Texas Department of Housing and Community Affairs

Board Action Request

Presentation, discussion, and possible action regarding a Material Amendment to the Housing Tax Credit Application for Ekos at the Preserve (HTC #20083)

Re: Amendment Request for Ekos at the Preserve #20083, in Irving, Texas

CLUBHOUSE FLOOR PLAN
SCALE: 3/16" = 1'-0"

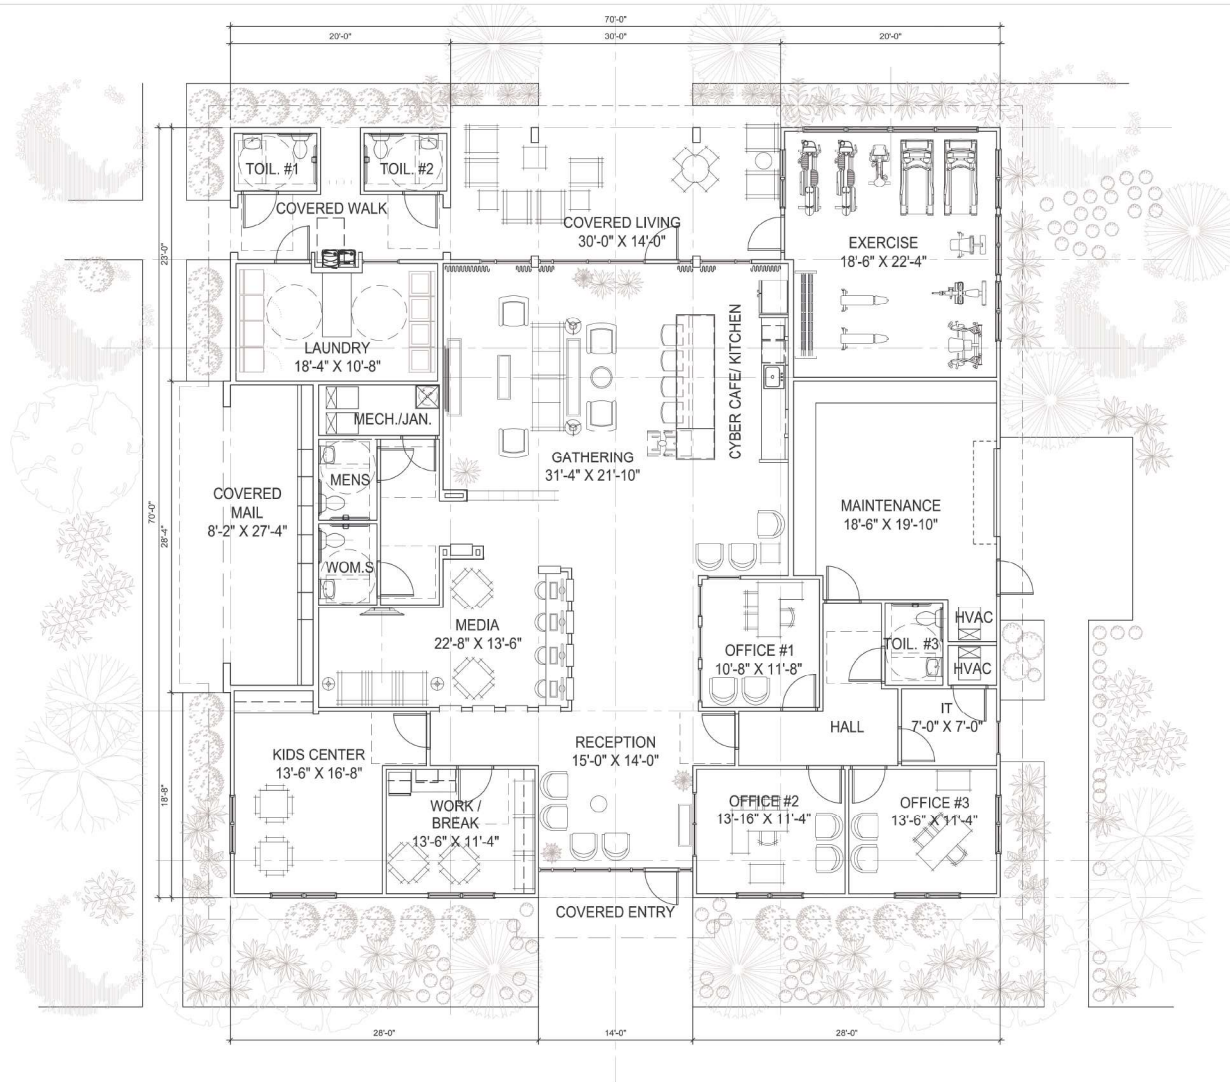
Moved to outdoor area

Laundry put in individual units

These are the areas enumerated on the Common Area calculation sheet.
